Memorandum

March 7, 2006 Planning Board Workshop

Morrill's Crossing Mixed-Use Development

Response to Comments

Landscape Plan 2

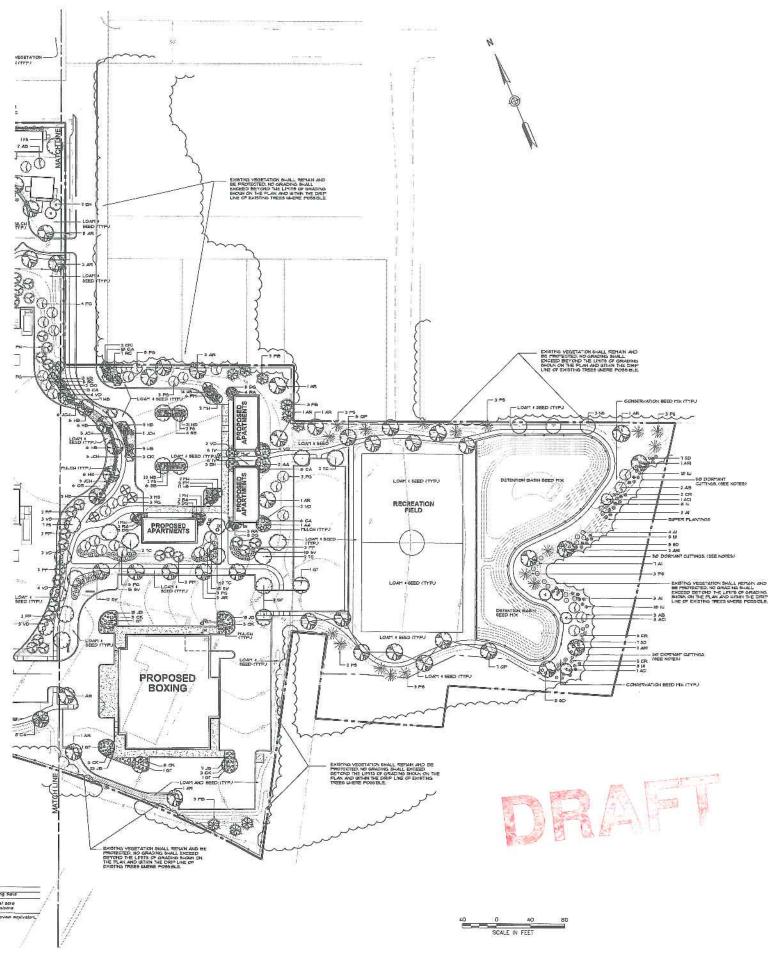
Comment (page 2 of 4):

Comment (page 2 of 4):

...with the exception of the supermarket service area, where additional evergreen trees, lower shrub masses, and fencing could be used to provide significantly more screening of this activity than proposed. It is also recommended that the applicant consider providing shrub understory massings where Austrian Pines are indicated.....

Comment (page 3 of 4):

Tree plantings indicated within cutouts in the sidewalks at the mixed-use building and other retail buildings appear to be located within very small openings (3'x3') in the pavement. Based on our experience and discussions with the City Arborist, the minimum opening size should be 24 SF, or and area approximately 6'x4'.

Comment (page 3 of 4):

There is no street tree planting or other landscaping proposed in front of the supermarket and it appears that there are locations where some level of planting could be installed. This would greatly soften the front façade of the building...

Comment (page 3 of 4):

Drawings and notes should be revised to better indicate the areas and means of tree protection.

Large evergreens have been added to infill between the proposed Maple Trees creating additional screening to the back of the buildings throughout the year.

Additional large evergreens and understory shrubs adjacent to the service area have been added including: Dense upright evergreen shrubs and perennials to create screening, year round interest and continuity for visual appeal from the apartments.

Freestanding planters have been added to the plan in front of the two Proposed Retail buildings south of the Proposed Stop & Shop. Planters will be a minimum of 5'x5' containing one large ornamental plant encompassed by proposed annuals. Stop & Shop has found that plantings in the walkway along the front of the store actually create conflicts due to the volume of customers with shopping carriages.

Curbing has been added to these areas on the plans to protect the proposed plantings.

Tree protection has been added to the plans in several locations the notes have been revised to reflect the suggestions. The landscape notes have also been revised and now refer to the Tree Protection Fence Detail.

The Plan Maintenance Notes have been revised in order for the contractor to provide a complete maintenance program to the owner for plant and lawn care.

Driveway Reconstruction Exhibit Paul White Tile Property Morrill's Crossing Portland, Maine

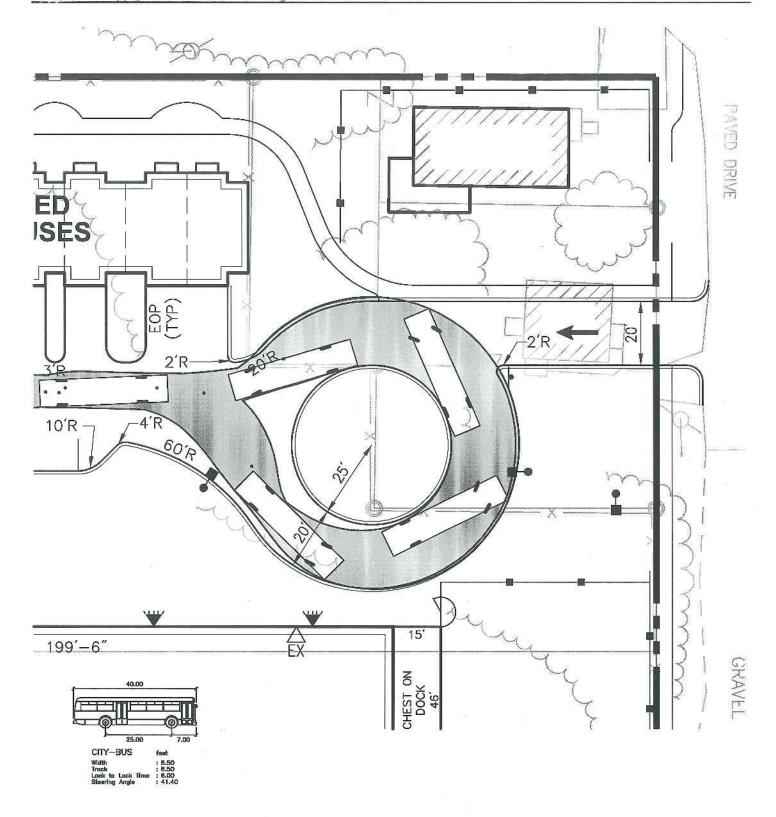
17. The applicant shall provide information on proposed site layout changes at Paul White Tile as part of the Allen Avenue improvements.

An exhibit showing the proposed site plan modifications to the Paul White Tile site is included (Comment 17 Attachment)
